Residential Use SITE EVALUATION-THIS IS NOT A PERMIT

Barry-Eaton District Health Department

Site Address: **LOT L CANFIELD RD**
EATON RAPIDS, Section #: 017

Parcel Size: **159** Eval. #: **SE19-094**

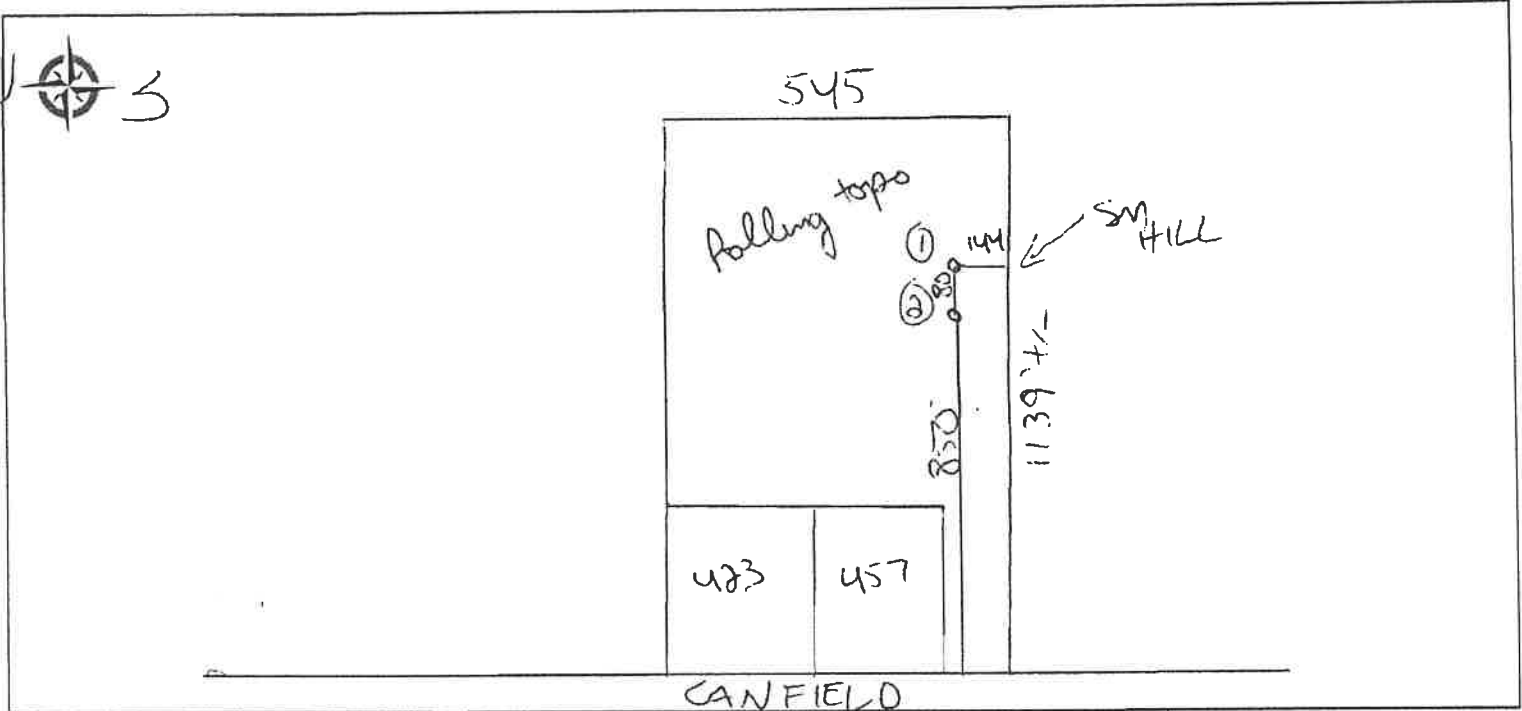
This site can be approved for a "bottom of stone at grade" system in the area surrounding holes 1 and 2.
